RE: 115 El Camino Real: Summary of changes from approved permit drawings.

Architectural control and use permit application.

05/08/25

# 115 EL CAMINO REAL

PROPOSED CHANGES TO APPROVED ELEVATIONS

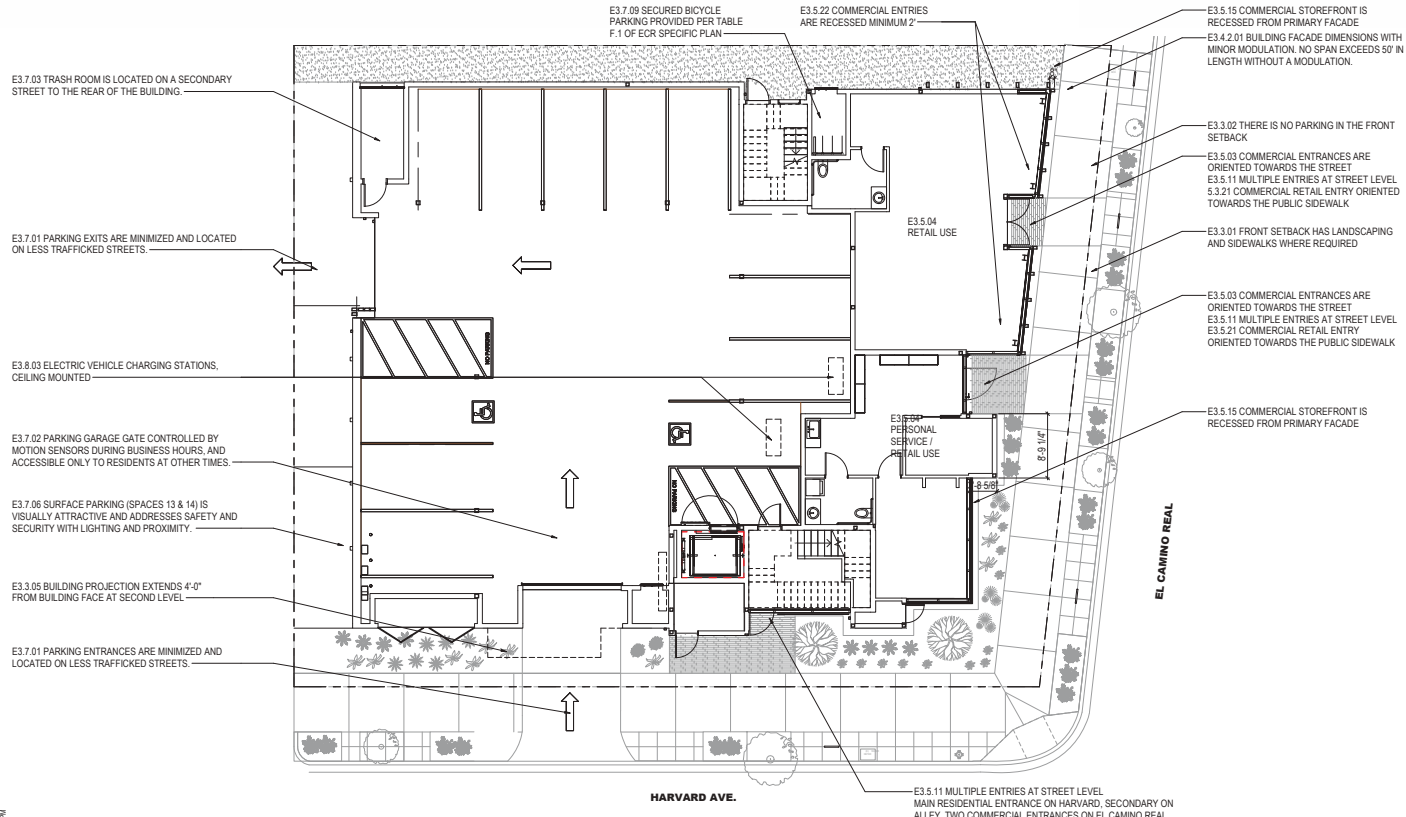
ELEVATION SOUTH FACING HARVARD AVE:

APPROVED PERMIT SET SHOWS GROUND FLOOR COMMERCIAL WALL AND RESIDENTIAL LOBBY SURFACE AREA = 367 SF  
367 X .50 TRANSPARENCY REQ. = 183 SF MINIMUM CLEAR GLAZING  
GROUND FLOOR COMMERCIAL AND RESIDENTIAL LOBBY GLAZING SURFACE AREA = 176 SF AS SHOWN IN THE APPROVED PERMIT SET.  
THE 176 SF IS INCORRECT. THE CORRECT AREA AS SHOWN IN THE APPROVED PERMIT SET IS 261 SF OF GLAZING.  
THE PROPOSED CHANGES SHOW A REDUCTION FROM THE 261SF TO 255 SF OF GLAZING WHICH IS STILL WITHIN THE GUIDELINES.  
GROUND FLOOR COMMERCIAL AND RESIDENTIAL LOBBY GLAZING SURFACE AREA = 255 SF AT HARVARD ST SIDE.

ELEVATION EAST FACING ECR: APPROVED PERMIT SET SHOWS:

COMMERCIAL GROUND FLOOR WALL SURFACE AREA = 898 SF  
898 X .50 TRANSPARENCY REQ. = 449 SF MINIMUM CLEAR GLAZING  
COMMERCIAL GROUND FLOOR GLAZING AREA = 658 SF

THE PROPOSED CHANGES SHOW A REDUCTION FROM THE 856 SF OF COMMERCIAL GROUND FLOOR GLAZING AREA TO 658 SF  
PROPOSED COMMERCIAL GROUND FLOOR GLAZING AREA = 658 SF  
COMMERCIAL GROUND FLOOR WALL SURFACE AREA = 1,100 SF  
1,100 X .50 TRANSPARENCY REQ. = 550 SF MINIMUM CLEAR GLAZING

1 ELEVATION EAST - FACING EL CAMINO REAL-PROPOSED CHANGES  
SCALE: 1/4" = 1'-0"

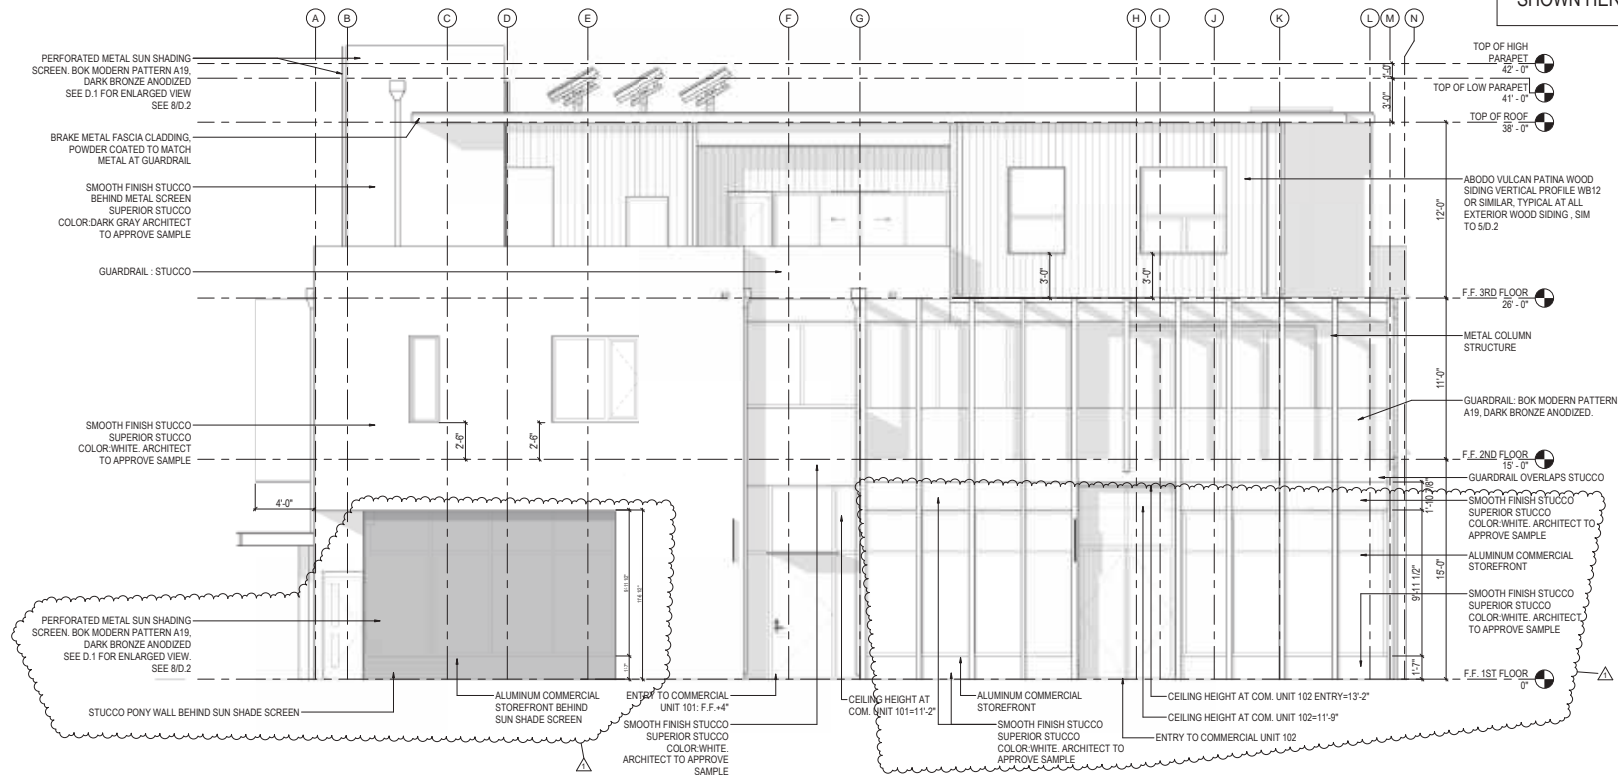
- REDUCED HEIGHT OF GLASS TO IMPROVE SAFETY AND TO ALIGN THE EXTERIOR GLAZING HEIGHT TO INTERIOR CEILING HEIGHT.
- WINDOW OPENINGS ARE THE SAME AS APPROVED PLANNING SET. THAT APPROVED SET DID NOT INCLUDE SPECIFIC DIVISIONS WITHIN THOSE OPENINGS, THE APPROVED BUILDING SET AND WINDOWS AS INSTALLED ARE AS SHOWN HERE.

1 ELEVATION SOUTH - FACING HARVARD AVE-PROPOSED CHANGES  
SCALE: 1/4" = 1'-0"

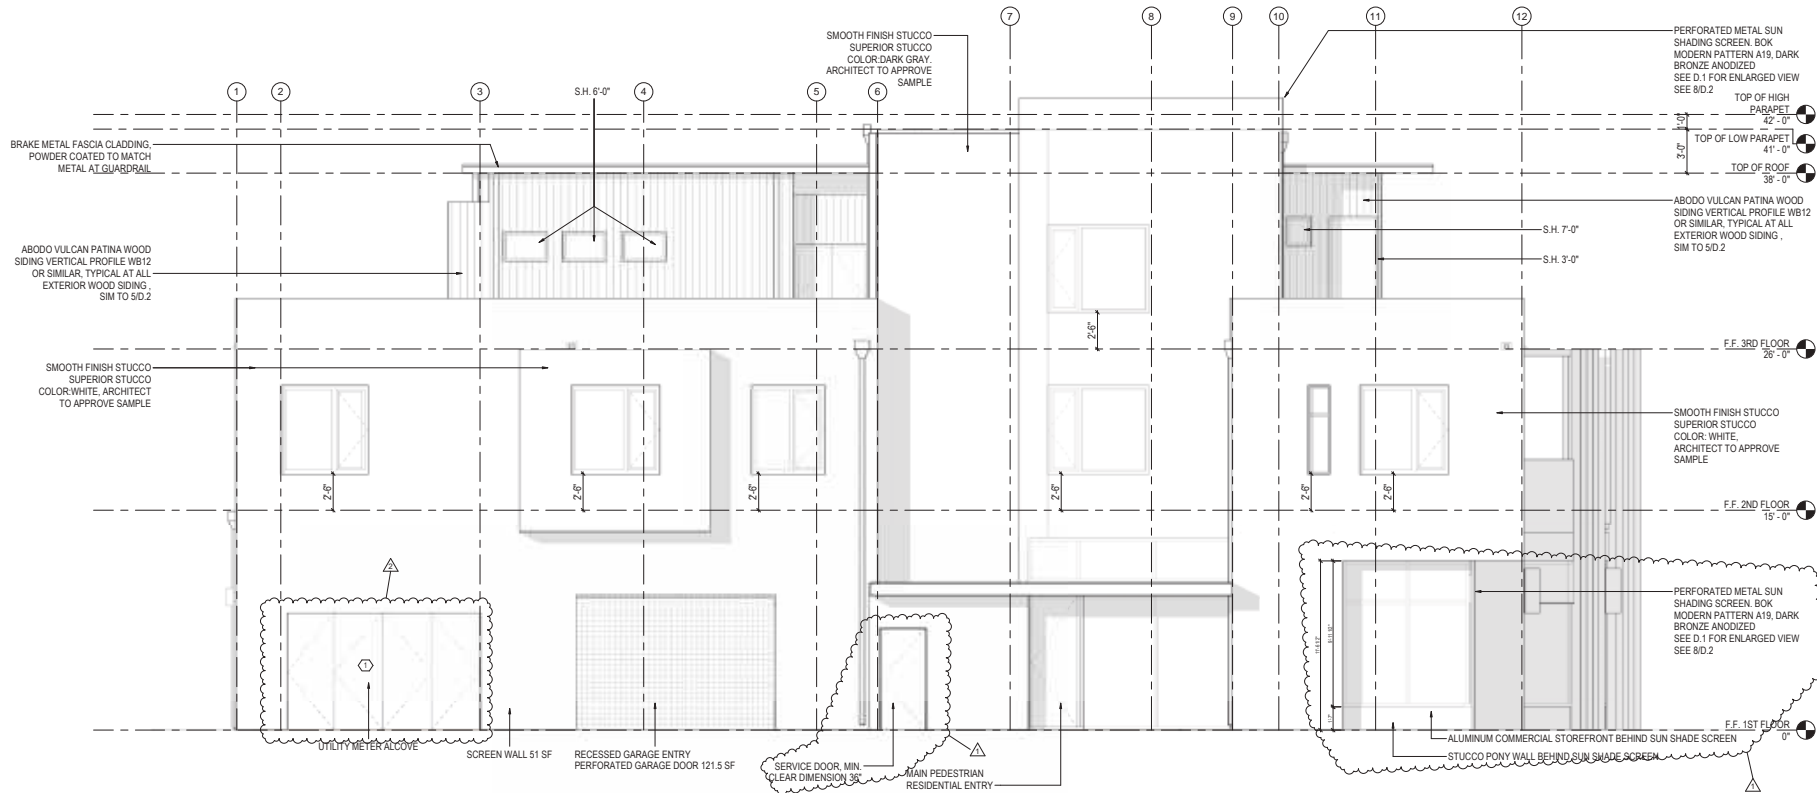
- REDUCED HEIGHT OF GLASS TO IMPROVE SAFETY AND TO ALIGN THE EXTERIOR GLAZING HEIGHT TO INTERIOR CEILING HEIGHT.
- ADDED SERVICE DOOR FOR ELEVATOR EQUIPMENT ACCESS.
- WINDOW OPENINGS ARE THE SAME AS APPROVED PLANNING SET. THAT APPROVED SET DID NOT INCLUDE SPECIFIC DIVISIONS WITHIN THOSE OPENINGS, THE APPROVED BUILDING SET AND WINDOWS AS INSTALLED ARE AS SHOWN HERE.

1 ELEVATION NORTH - FACING 135 ECR - PROPOSED CHANGES  
SCALE: 1/4" = 1'-0"

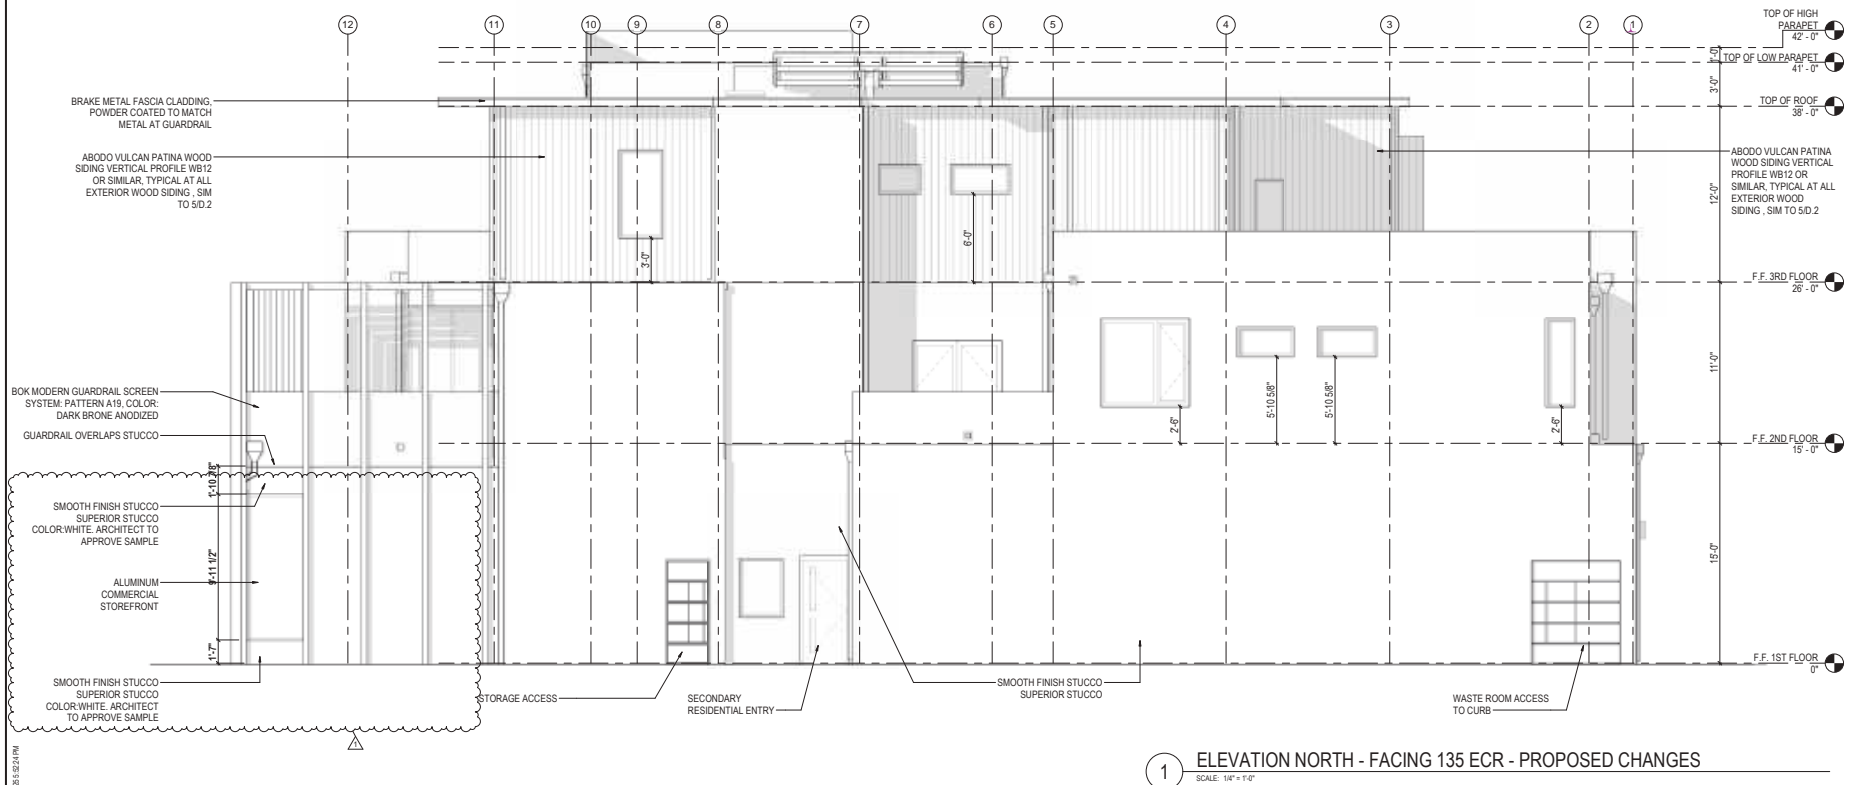
- REDUCED HEIGHT OF GLASS TO IMPROVE SAFETY AND TO ALIGN THE EXTERIOR GLAZING HEIGHT TO INTERIOR CEILING HEIGHT.
- TO IMPROVE PRIVACY: REDUCED LENGTH OF STOREFRONT AT NORTH SIDE COMMERCIAL UNIT 102 FACING THE NEIGHBOR AT 135 ECR. (AT FIRST FLOOR)
- WINDOW OPENINGS ARE THE SAME AS APPROVED PLANNING SET. THAT APPROVED SET DID NOT INCLUDE SPECIFIC DIVISIONS WITHIN THOSE OPENINGS, THE APPROVED BUILDING SET AND WINDOWS AS INSTALLED ARE AS SHOWN HERE.
- WINDOWS AT STAIR-WELL REMOVED. WINDOW AT SECOND FLOOR CHANGED TO GLASS DOOR. WINDOW CONFIGURATION AT SECOND FLOOR CHANGED, AND WINDOWS ADDED AT THE THIRD FLOOR.
